# Southern Company Interim Policy Lease Application Addendum B

Data Collection Project  
Offshore of Tybee Island, Georgia

**Southern Company IP Lease Application – Addendum B**

This Addendum B to the 2011 Lease Application is intended to address the comments and information requests BOEM provided in their document entitled “Southern Company Interim Policy Lease Application & Addendum A Comment & Information Request Matrix, June 22, 2012” as provided under Appendix 4B of this Addendum B.

**Met Tower Assembly Drawings**

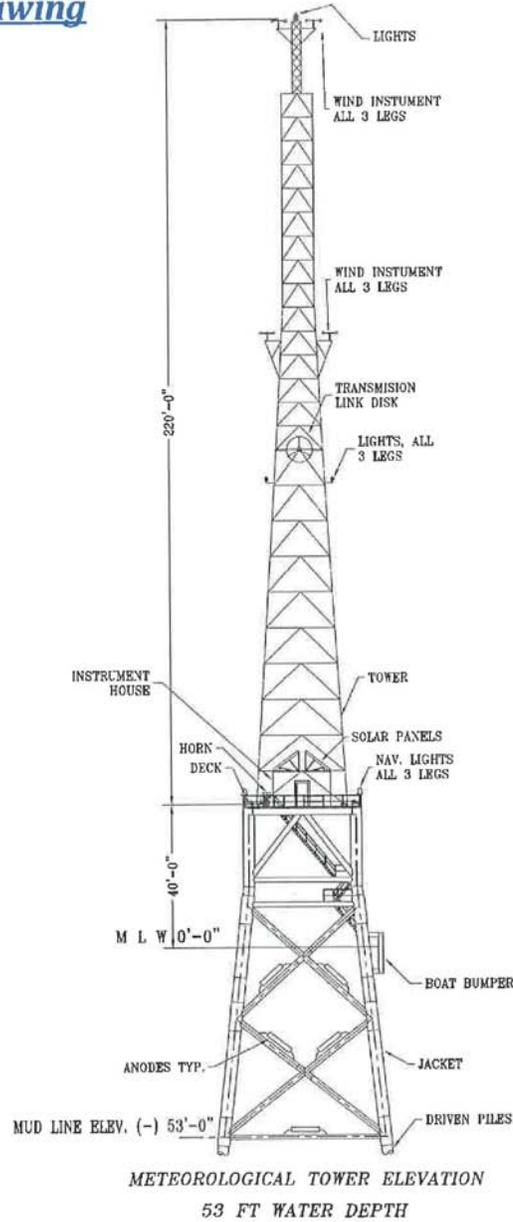
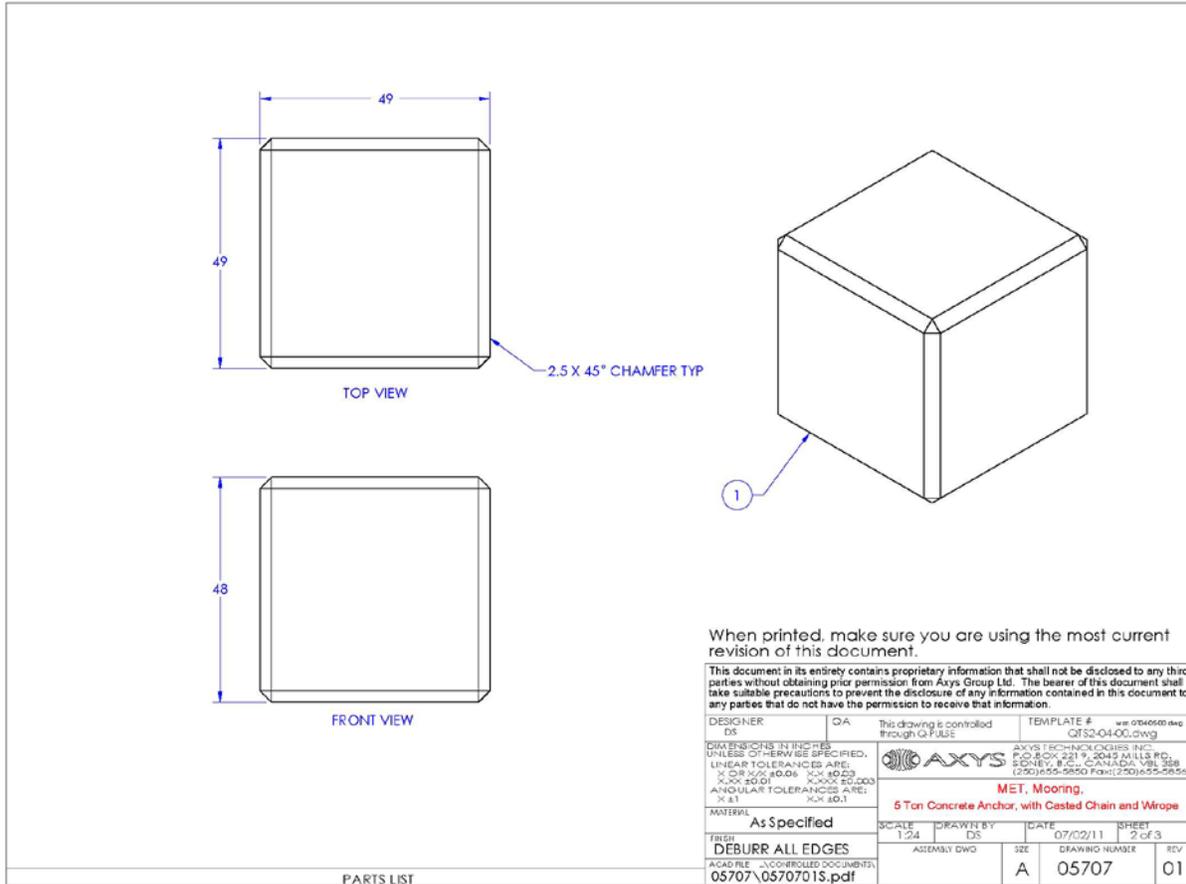
“There is a general description of the height of the tower and the penetration depth of piles but there lacks any description regarding the approximate bottom footprint (page 18 says “a few hundred square feet.” What is the method of installation? Approximate timing/duration of installation time? In some sections they seem to refer to scour protection devices but this information is lacking from section 2.4. A range of types and footprint and overall tower design with illustrations in one location in the document are needed.”

The three DCC piles will each be 36 inches in diameter (Addendum B, **Appendix 1B**). The method of installation is provided in section 2.4. The estimated duration of on-site installation is 12 days. Further investigation has revealed that scour protection devices should not be needed (Schellstead, 2012) as with “a small diameter pile, a general rule of thumb is that the maximum scour depth is equal to about twice the pile diameter” (Hughes, 2012). Southern Company wishes to regard all references to the use of scour protection as a possibility should geophysical/geotechnical survey data collection and subsequent engineering design require scour protection. If scour protection is considered, potential scour protection devices or a scour protection plan will be developed for evaluation by BOEM. The tri-pile DCC tower design is the only met-tower design being considered in the Application. The preliminary DCC Assembly Drawings are provided in Appendix 1B.

**Proposed Derrick Barge Anchor Pattern**

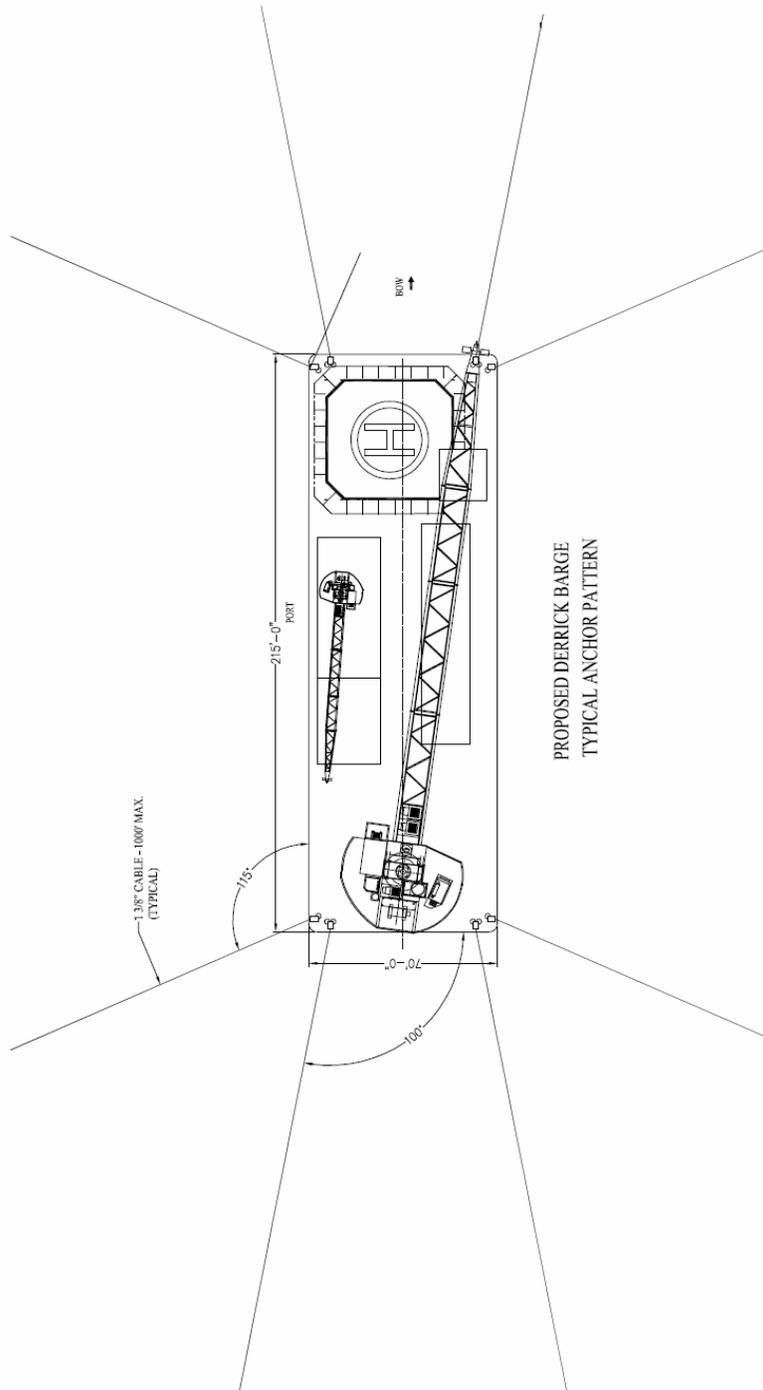
“Provide distances between anchor points, diameter and radii for the proposed Derrick Barge Anchor Pattern.”

See the 2011 Lease Application section 2.8.1.1 – Sea Bottom Disturbances, and Appendix A – Proposed Vessels and Anchoring Patterns. To further illustrate the derrick barge anchor pattern, **Addendum B, Appendix 3B** is included in this document.
